# UNITED STATES PATENT AND TRADEMARK OFFICE

APPLICATION NO.	FILING DATE	FIRST NAMED INVENTOR	ATTORNEY DOCKET NO.	CONFIRMATION NO.
10/580,091	05/18/2006	Jurgen Oetjen	188.613	7492
47888 7590 06/12/2008 HEDMAN & COSTIGAN P.C. 1185 AVENUE OF THE AMERICAS NEW YORK, NY 10036				
EXAMINER				
DIAZ, THOMAS C				
ART UNIT		PAPER NUMBER		
4171				
MAIL DATE		DELIVERY MODE		
06/12/2008		PAPER

# Office Action Summary

## DETAILED ACTION

Figure i- Applicant's roller screw.

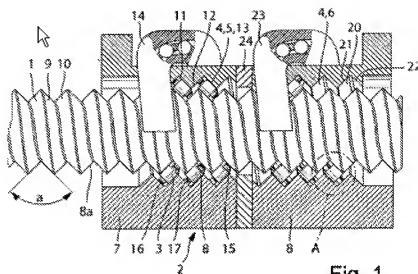
- "a" has been used to designate both an angle in fig.1 and a distance in fig.2.
- "8" has been used to an unspecified area in fig. 1 and a 2<sup>nd</sup> nut part in fig.1.

- Reference numerals (4,5,13) in figure 1 are pointing to one location and referencing multiple parts. It is unclear how to distinguish the parts.

- Reference numerals (18,19), (27,8a), (20, 26) in figure 2 are pointing to one location and referencing multiple parts. It is unclear how to distinguish the parts.

- In claims 4 and subsequent dependent claims from 4, the applicant claims a cage having belts which have webs and also claims pockets. These features are labeled in the drawings as the same thing. It is unclear to the examiner where exactly the features are shown. These features should be distinguished so that they are clearly shown in the figures.

Corrected drawing sheets in compliance with 37 CFR 1.121(d) are required in reply to the Office action to avoid abandonment of the application. Any amended replacement drawing sheet should include all of the figures appearing on the immediate prior version of the sheet, even if only one figure is being amended. Each drawing sheet submitted after the filing date of an application must be labeled in the top margin as either "Replacement Sheet" or "New Sheet" pursuant to 37 CFR 1.121(d). If the changes are not accepted by the examiner, the applicant will be notified and informed of any required corrective action in the next Office action. The objection to the drawings will not be held in abeyance.

Figure ii- Nishimura et al.'s roller screw.

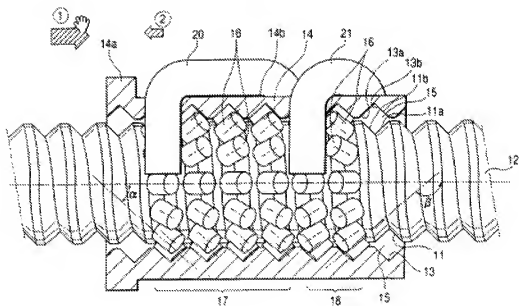
Nishimura et al. discloses a similar roller screw to applicant's roller screw, both seen below:

- A spindle nut (fig.1, 14) arranged on a threaded spindle (fig.1, 12),
- Rollers (fig.1, 16) which are arranged such that they can roll in a thread path (fig.1, 15),
- The thread path being delimited by thread grooves (fig.1,13, 11) provided on the threaded spindle and on the spindle nut,
- Wherein two equal pitches of the thread grooves are arranged so as to be axially offset with respect to one another by a partial amount of the pitch.

Figure iii- Nishimura et al.'s device.

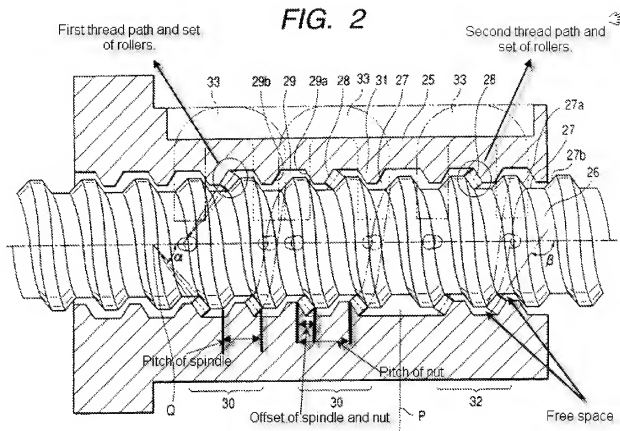
(This is seen in figure 2, below.)

This is labeled in figure 2. Both sets of rollers are on different thread paths or different flanks.

This is also clear from figure 2, according to the labels of the first and second sets of rollers made by the examiner.

This is also clear from the labeled portions in figure 2. Both sets roll on a different set of flanks.

The two thread flanks of the thread groove are perpendicular to each other as taught col.5, lines 64-67. From figure 2, the partial amount labeled is approximately 30% of the absolute value of the pitch.

Figure v- Greby's roller screw.

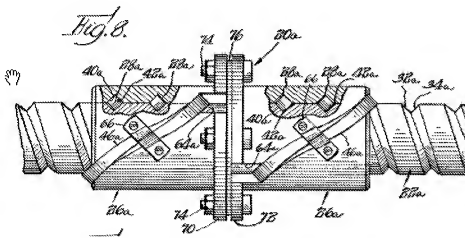
Greby teaches nut parts both labeled 26a in figure 8 and mentioned col.5, lines 24-29, where Greby further discusses these nut parts allow for sustaining thrust loads in two directions.

Greby teaches a spacer (fig.8, 76) for the purpose of preloading the rollers and eliminate axial play of the nuts on the screw (col.5, lines 35+). This shim can be adjusted.
